REQUEST FOR COUNCIL ACTION

Originating Department COMMUNITY DEVELOPMENT	By rms	Approved for Agenda by:	Date: Time:	Number:
Agenda Section DEVELOPMENT BUSINESS		Item Variances, conditional use and final site plan and building plans for a restaurant

Item 2		Case 8946ABC-94		
GENERAL INFORMATION				
Applicant:		FourCrown, Inc.		
Location:		9624 Lyndale Avenue		
Request:		Variances to: A) Reduce landscaped yard from 20 feet to 9 feet (Case 8946A-94); and B) Increase the number of allowable signs from 2 signs to 4 signs (Case 8946B-94) Conditional use permit and final site plan and building plans for a freestanding restaurant		
Existing Land Use and Zoning:		Vacant commercial building; zoned CB		
Surrounding Land Use and Zoning:		North, South and East - Retail Commercial; zoned CB and CB(PD) West - Manufacturing; zoned I-3		
Comprehensive Plan:		The Comprehensive Land Use Plan recommends Retail Commercial land use for the property.		
PROPOSAL				
<p>The applicant is proposing to redevelop a 37,337 square foot lot for a 119 seat freestanding restaurant. The existing structure would be removed and a new one-story 3,793 square foot brick restaurant building would be constructed. Access f

FLOOR PLAN AND SCHEDULES

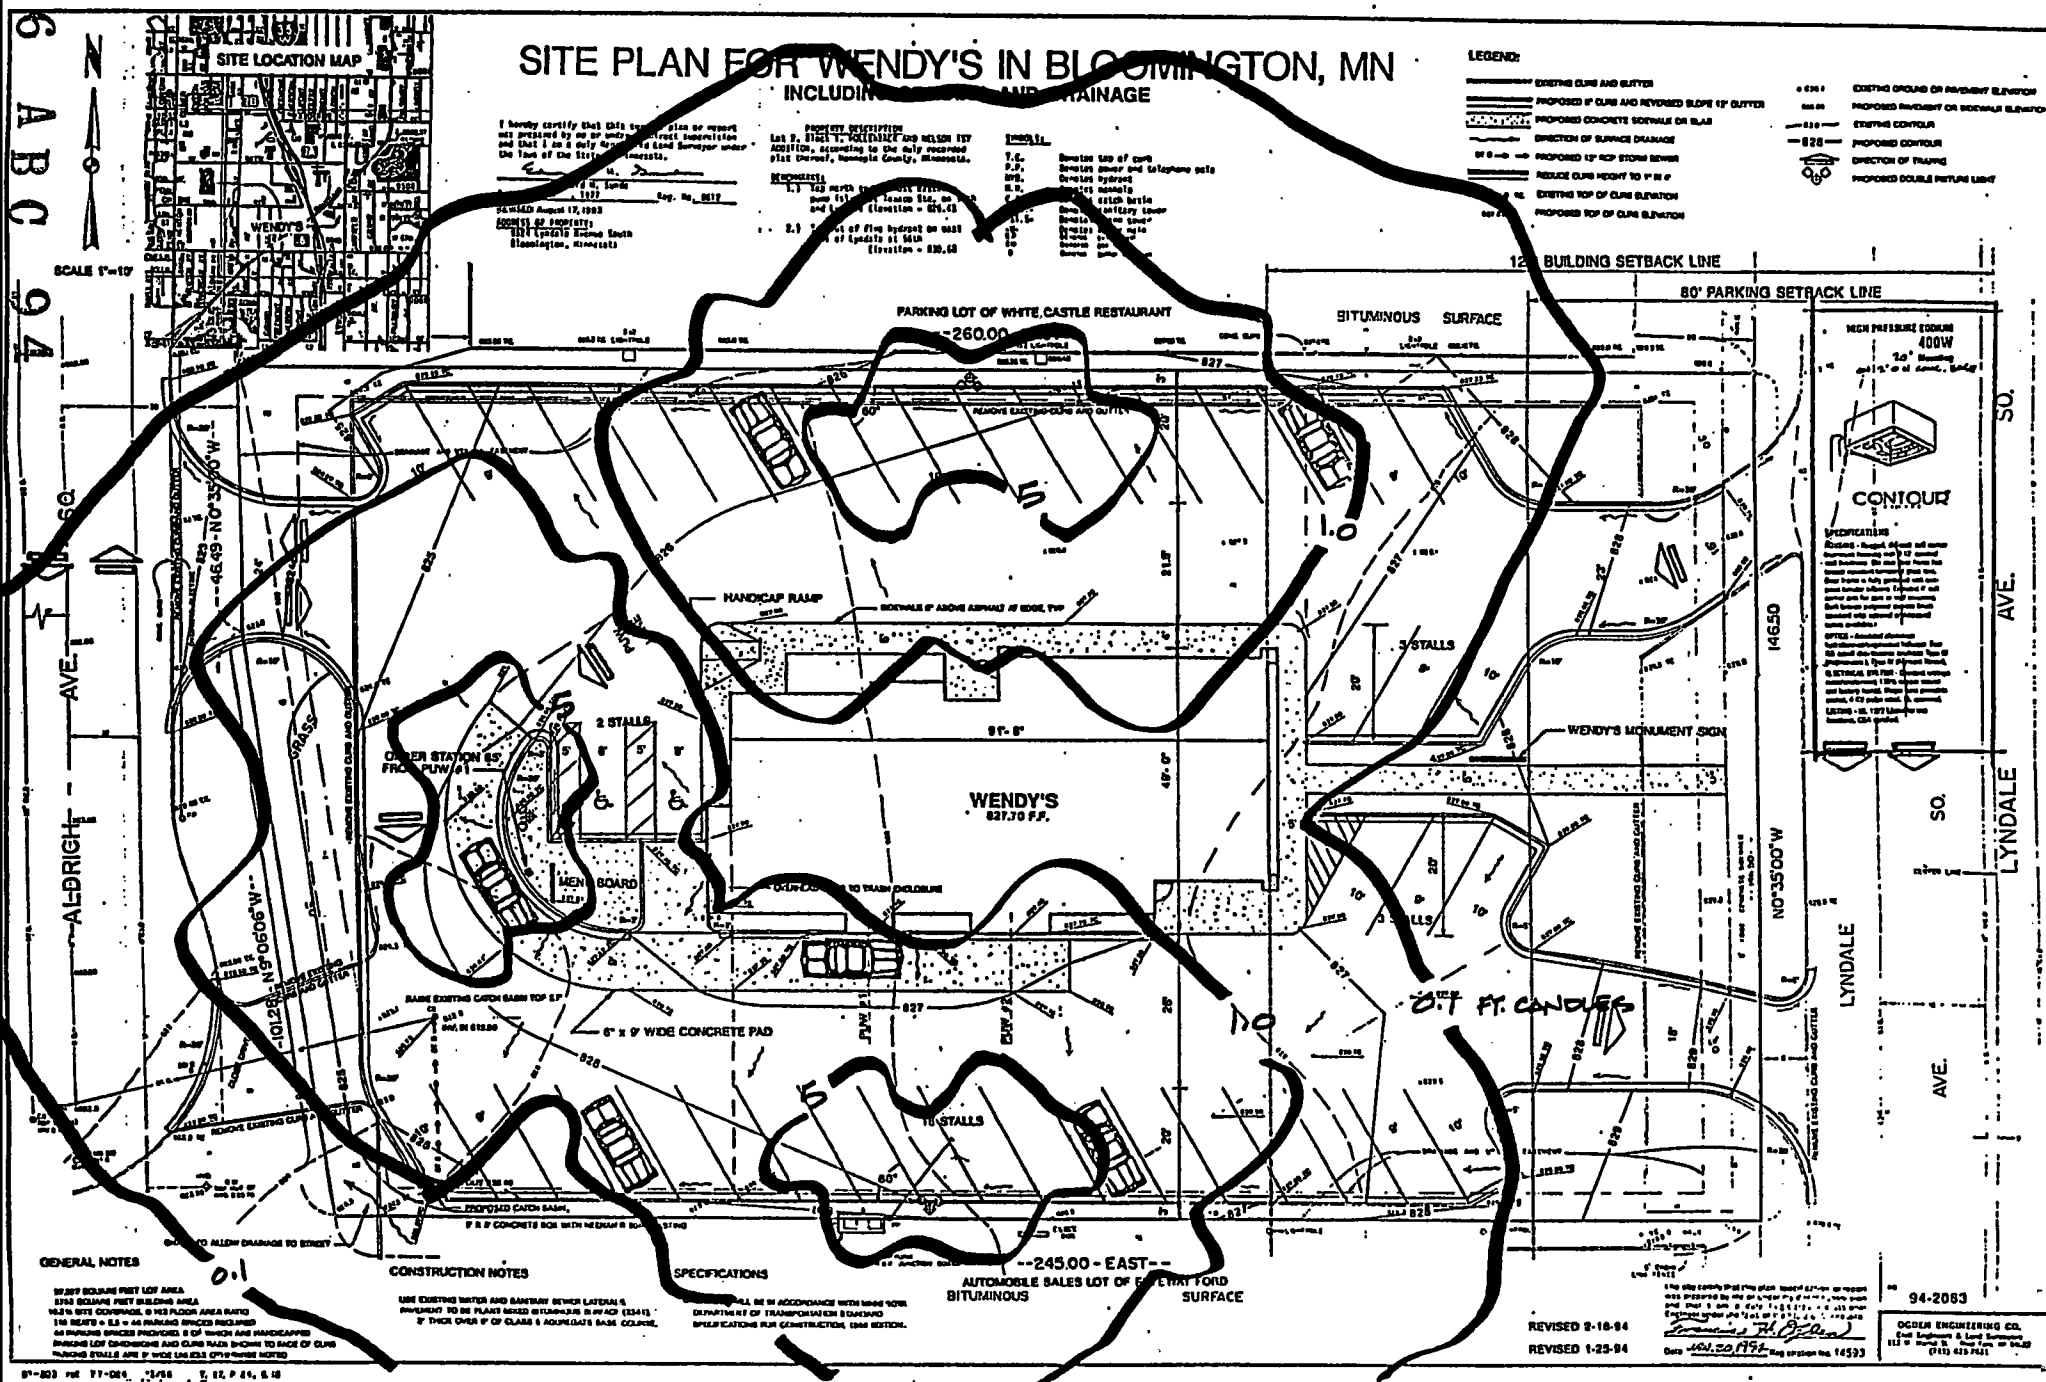
It is noted that the building area as proposed is 3,793 square feet or 207 square feet less than the minimum building area requirement contained in the CB Central Business District. The applicant will have to provide a minor expansion building area in order to conform to the building area requirement. This minor modification should be included as a condition of approval.

- 8) Alterations to utilities be at the developer's expense;
- 9) Building be provided with an automatic fire sprinkler system as approved by the Fire Marshal;
- 10) Building area not be less than 4,000 square feet with final coverage layout to be approved by the Planning Manager;

TITLE: LANDSCAPE PLAN

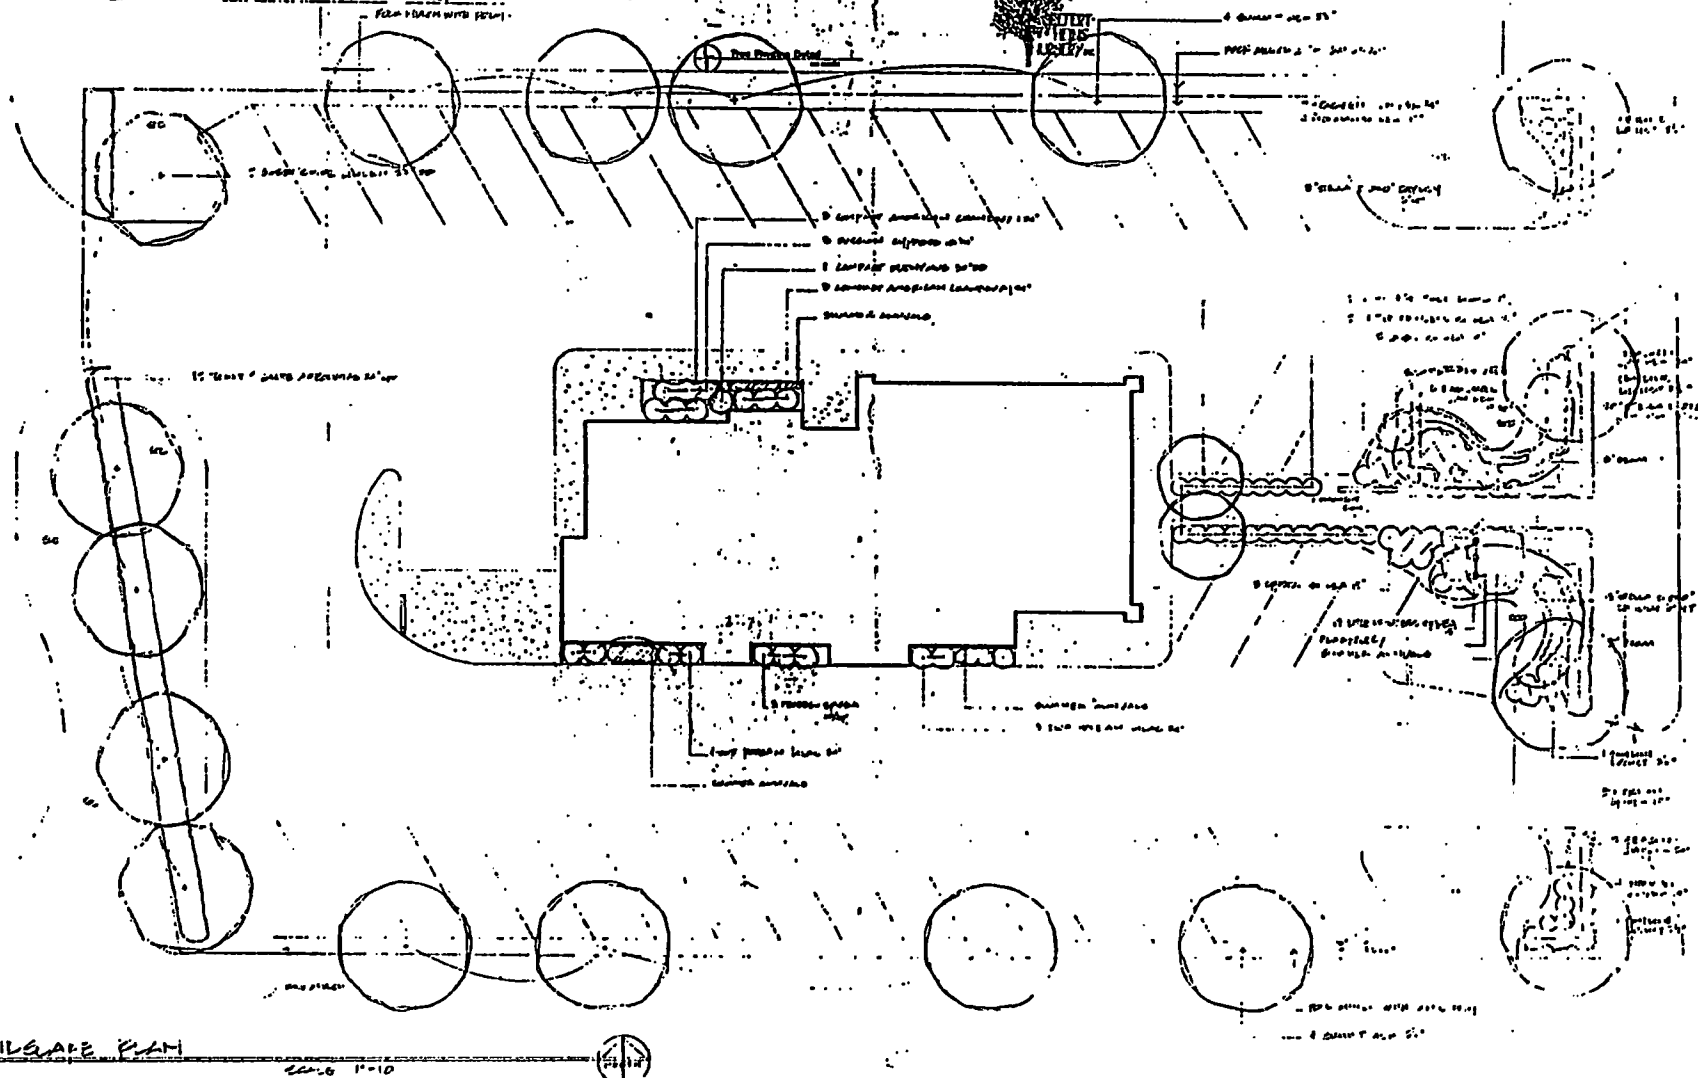
A conceptual landscape plan has been submitted noting perimeter shade tree plantings along the north, south and west property lines. Foundation plantings of low growing shrubs is proposed along the north and south sides of the building. Planting beds extend along a front sidewalk area to Lyndale Avenue. Streetscape plantings along the yard area adjacent to Lyndale Avenue is composed of deciduous shade or boulevard trees and shrubs. A finalized landscape plan, modified to incorporate elements of the Oxboro Redevelopment streetscape program, should be included as a condition of approval.

The variance request to reduce the width of the landscaped yard from 20 feet to 9 feet is related to the entry-exit modification along Aldrich Avenue. As noted, the applicant is proposing to close the southern-most entry on the cul-de-sac portion of Aldrich Avenue and construct a new entry-exit point at the northwest corner of the property. The irregular rear lot contains a break point that follows the angled right-of-way line of Aldrich Avenue. The irregular shape of the rear portion of the lot is a factor in establishing a full 20 foot wide landscaped yard area. The reduced yard area should provide adequate separation from the adjacent circulation drive.

- 1) Landscape plan including Oxboro Redevelopment Area streetscape improvements be approved by the Planning Manager (Sec 19.52);
- 2) All rooftop equipment be fully screened (Sec. 19.52.01);
- 3) Poured-in-place concrete curbs be provided on the perimeter of parking lots and traffic islands (Sec 19.64);
- 4) Building be provided with an automatic fire sprinkler system as approved by the Fire Marshal (Mn Bldg Code 3802; Uniform Fire Code Ch 10.306);
- 5) Utility plan showing location of existing and proposed water main and fire hydrant locations be approved by the Fire Marshal and Utilities Engineer (Sec. 6.20, Uniform Fire Code Ch. 10.301-C);
- 6) Food service plans be approved by the Environmental Services Division (Sec. 14.360); and,
- 7) Fire lanes be posted as approved by the Fire Marshal (Sec. 8.73).
